PERFORMANCE BULLETIN 121

Metal Valve Single Piece Shaft Update

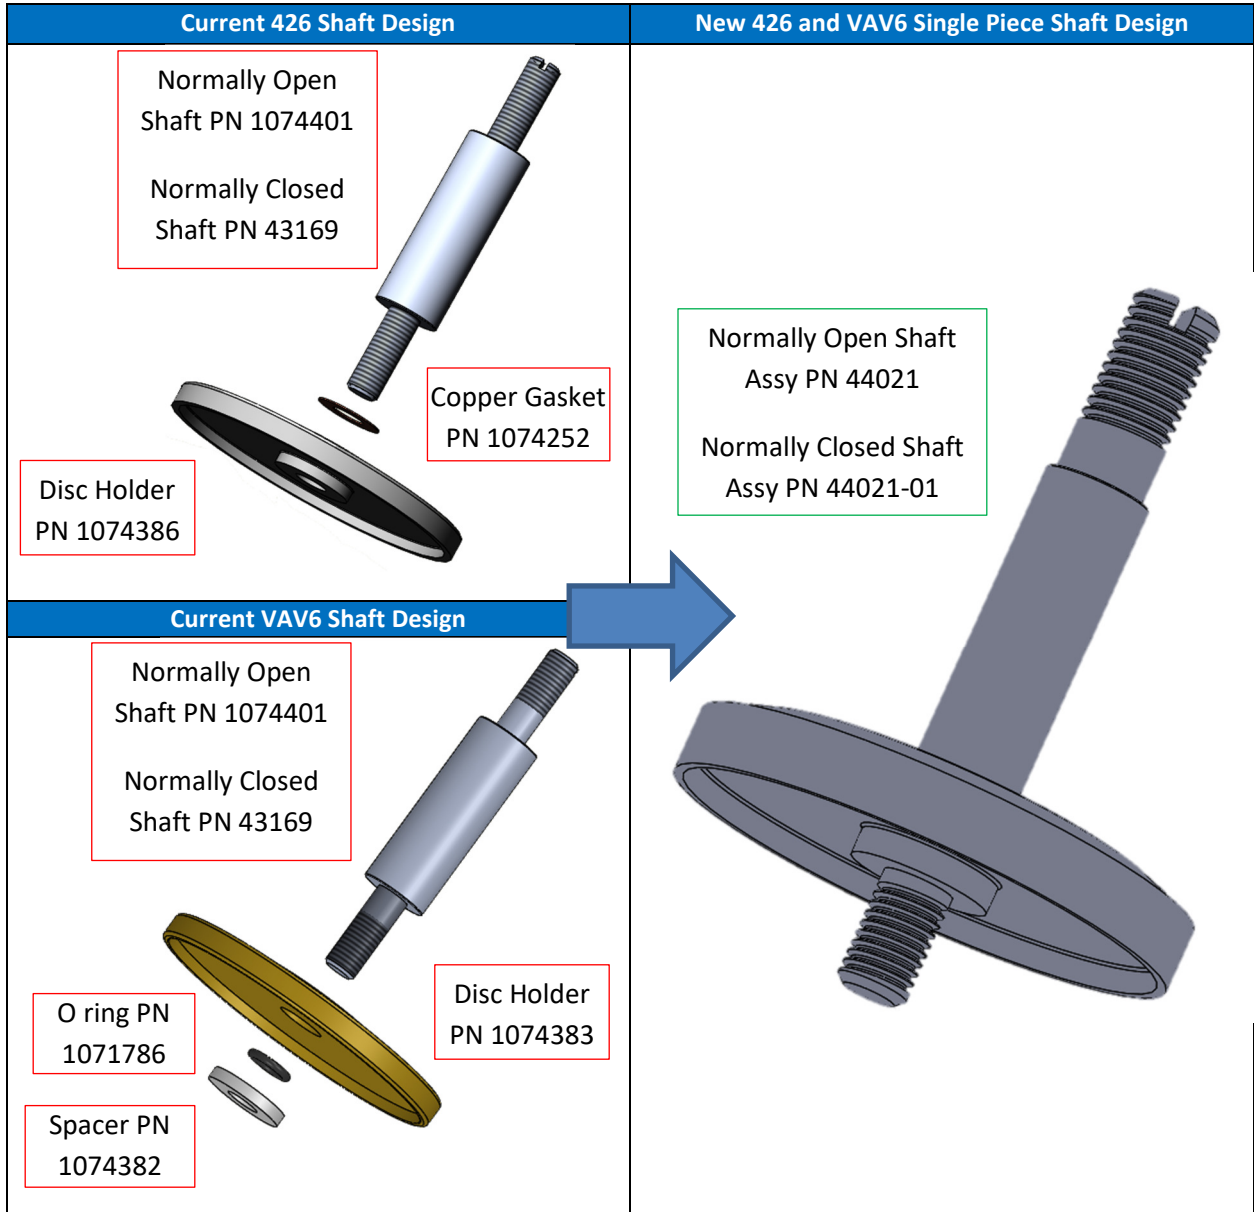
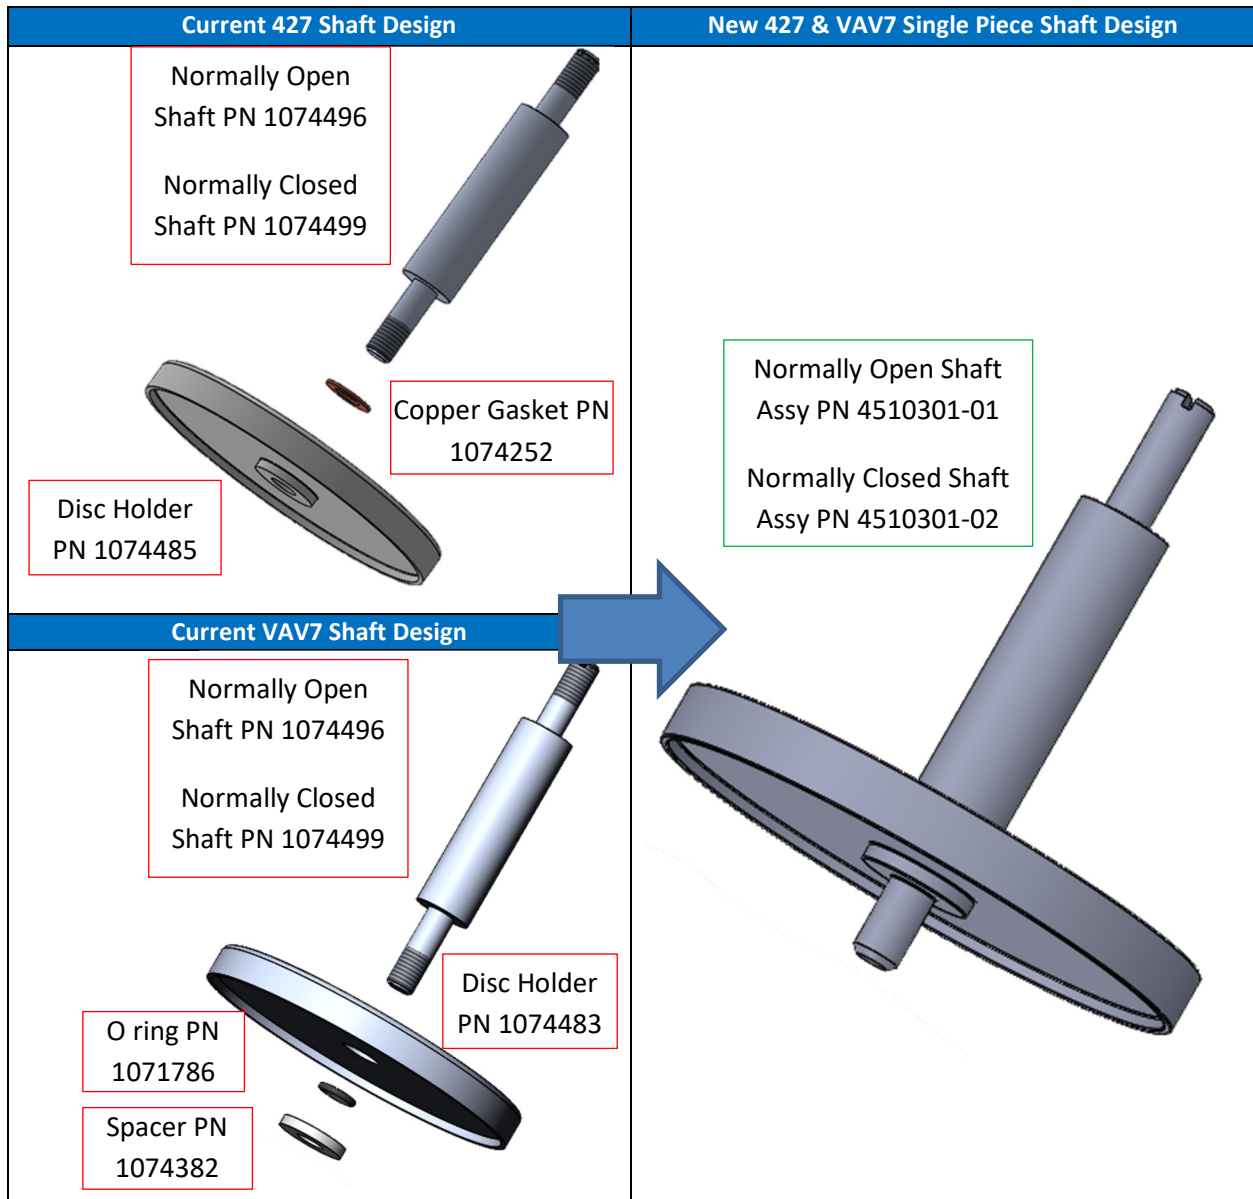
The Shaft for 2", 2.5", 3", and 4" metal valves (V426, VAV6, V427, VAV7, V428, and VAV8) are being updated to a new single piece design. This new design incorporates the shaft and disc holder into a single casting eliminating one potential leak point within the valve. The assembled dimensional characteristics will not be affected. As a result of this change, the Internal Parts Repair Kits will include the single piece shafts. Part numbers for Internal Part Kits and valve assemblies will remain the same. The new shafts are fully interchangeable with the old design and will be available once inventory of the old design is exhausted.

Because of this change, new Part Numbers are being introduced to replace the old shaft and disc holder Part Numbers as shown below:
